Name of Project	Franklin Hills Estates & Country Club	CGP Tracking No.	IR #20-10	Inspection Date	12/10/2020
Inspector Name, Title & Contact Information	Inspector: Jacob Faulise, E.I.T.		Reviewer: David McKay, P.E.		
Present Phase of Construction	Phase 1				
Inspection Location (if multiple inspections are required, specify location where this inspection is being conducted)	Areas of Concern as defined at site walk with wetlands commission				
<p>Inspection Frequency (Note: you may be subject to different inspection frequencies in different areas of the site. Check all that apply.)</p> <p>Standard Frequency: <input type="checkbox"/> Weekly <input type="checkbox"/> within 24 hours of a 0.5" rain</p> <p>Increased Frequency: <input type="checkbox"/> Every 7 days and within 24 hours of a 0.5" rain (for areas of sites discharging to sediment or nutrient-impaired waters or to waters designated as Tier 2, Tier 2.5, or Tier 3)</p> <p>Reduced Frequency:</p> <ul style="list-style-type: none"> - <input checked="" type="checkbox"/> Once per month (for stabilized areas) - <input type="checkbox"/> Once per month and within 24 hours of a 0.5" rain (for arid, semi-arid, or drought-stricken areas dur

Photo 3: Sediment fence and stone check dams installed across the 15th hole green remain in good condition overall and are functioning as intended with ample storage capacity available.

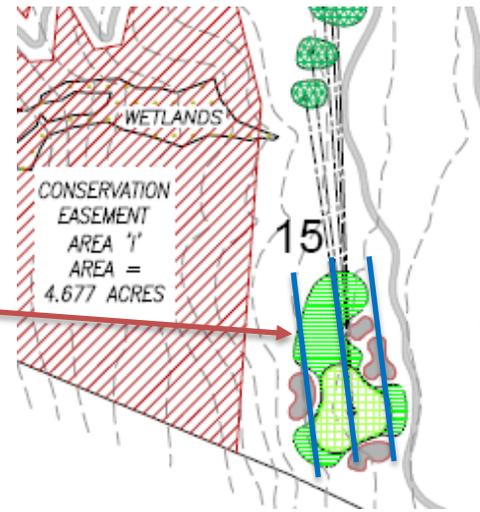
2. 15 th Green Sediment Barriers	<input checked="" type="checkbox"/> Yes <input type="checkbox"/> No	<input type="checkbox"/> Yes <input checked="" type="checkbox"/> No		Stone check dams and sediment fence rows across 15 th Hole green remain in good condition overall (Photo 3). Sediment fence rows and staked hay bales in one area have deteriorated and need to be replaced (Photo 4). Downgradient stone check dam remains in good condition. Sediment fence along tree line has undermined in two locations and should be repaired.

Photo 5: Stone check dams, staked hay bales, and sediment fence remain in good condition with ample storage capacity available.

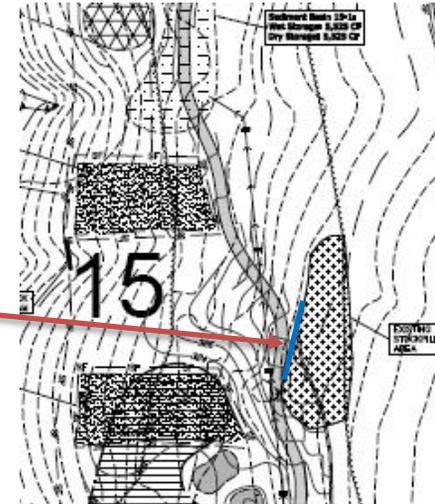
3. 15 th Fairway Sediment Barriers	<input type="checkbox"/> Yes <input checked="" type="checkbox"/> No	<input type="checkbox"/> Yes <input checked="" type="checkbox"/> No		Stone check dams, stone apron, staked hay bales, and sediment fence are all in good condition and functioning as intended with ample storage available (Photo 5).

Photo 6: Staked hay bales and sediment fence at construction entrance have deteriorated and been removed since last inspection.

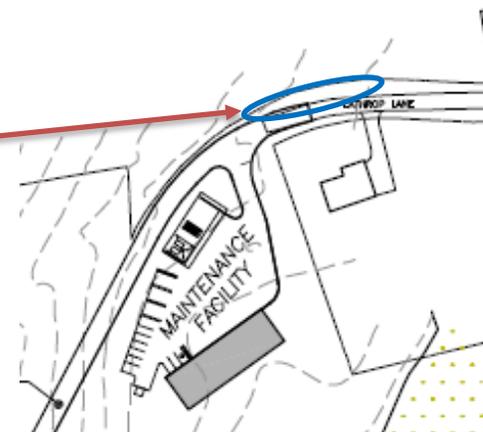
4. Construction Entrance (Westerly of Proposed Maintenance Road)	<input checked="" type="checkbox"/> Yes <input type="checkbox"/> No	<input type="checkbox"/> Yes <input checked="" type="checkbox"/> No		Stone check dam and water bar across construction entrance are in good condition and functioning. Staked hay bales and sediment fence are deteriorating and have been removed from flow path (Photo 6). Stone check dams should be added to new swale if erosion occurs.

Photo 7: Stone check dams, sediment fence rows, and staked hay bales across the 7th hole fairway hillside remain in good condition and are functioning as intended with ample storage capacity available.

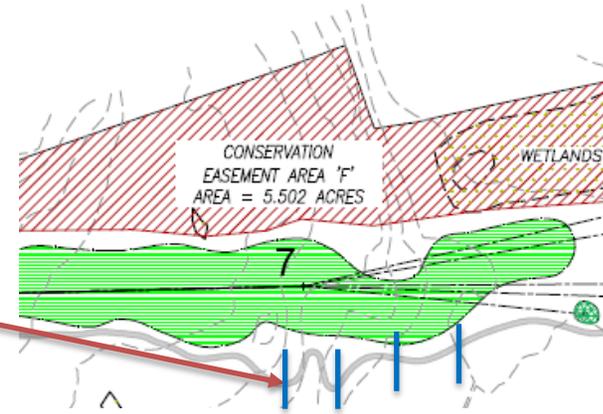
5. 7 th Hole Fairway Hillside	<input type="checkbox"/> Yes <input checked="" type="checkbox"/> No	<input type="checkbox"/> Yes <input checked="" type="checkbox"/> No		Sediment fence rows and check dams across 7 th Hole fairway are in good condition overall and functioning as intended with ample storage capacity available (Photo 7). Sediment fence has failed in several locations but remaining sediment barriers have area contained.

Photo 9: Sediment fence at tree line by 14th hole is allowing flow underneath in one location and needs to be repaired.

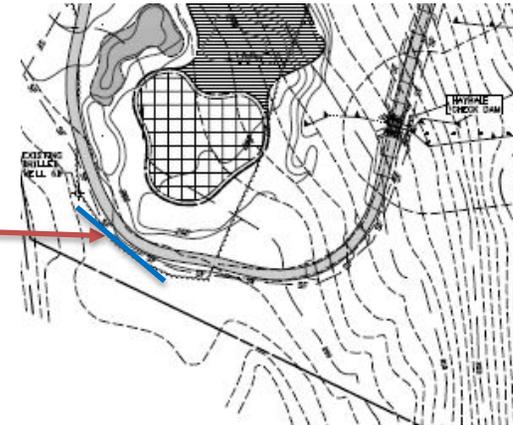
7. 14 th Hole Green Sediment Barriers	<input checked="" type="checkbox"/> Yes <input type="checkbox"/> No	<input type="checkbox"/> Yes <input checked="" type="checkbox"/> No		Sediment fence row at tree line is allowing flow underneath in one location and needs to be corrected (Photo 9).

Photo 10: Stone check dam downgradient from created wetlands outlet is no longer functioning as intended and should be replaced.

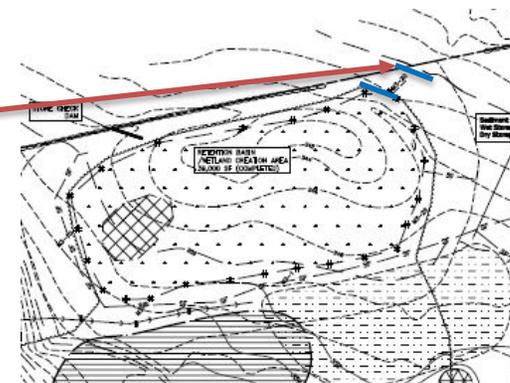
8. Created Wetlands Outlet	<input checked="" type="checkbox"/> Yes <input type="checkbox"/> No	<input type="checkbox"/> Yes <input checked="" type="checkbox"/> No		Stone check dam at outlet of created wetlands remains in good condition and is functioning as intended. Check dam downgradient needs to be replaced (Photo 10).
